Sail Auxiliary - D-7 Group No. 13 Fuel Lift Pump	June 4, 1981	Bulletin No. 13001 (1002)

Subject: Securing Fuel Lift Pump

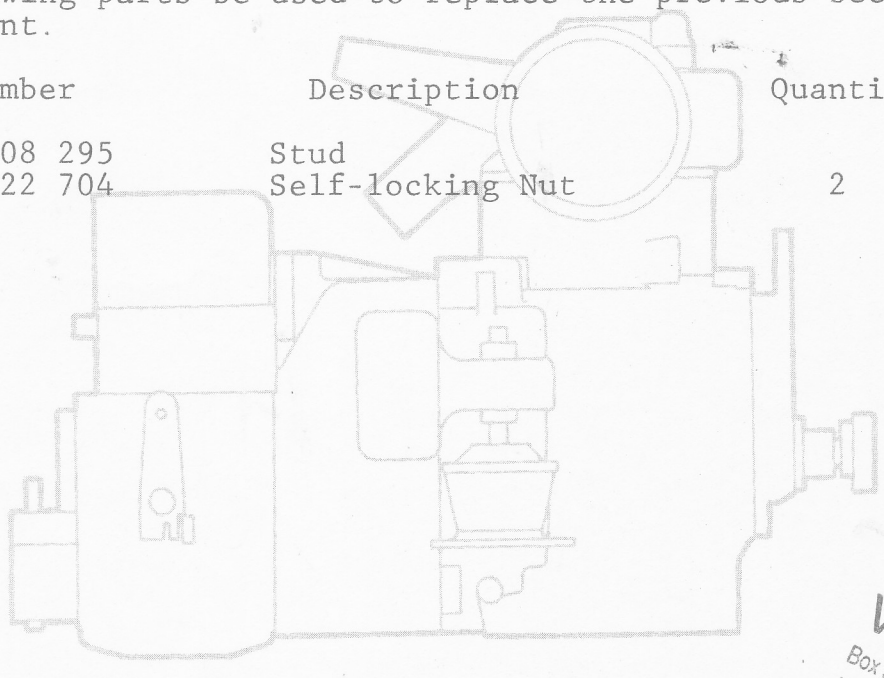
The securing of the fuel lift pump has been improved. From engine serial number 0956 the fuel lift pump is fastened with studs using Loc Tite 601 and self-locking nuts.

Previously, the lift pump was fastened with hexagon head bolts.

In case the fuel lift pump becomes loose, we suggest that the following parts be used to replace the previous securing arrangement.

Part Number	Description	Quantity
07 11 9 908 295	Stud	
07 12 9 922 704	Self-locking Nut	2
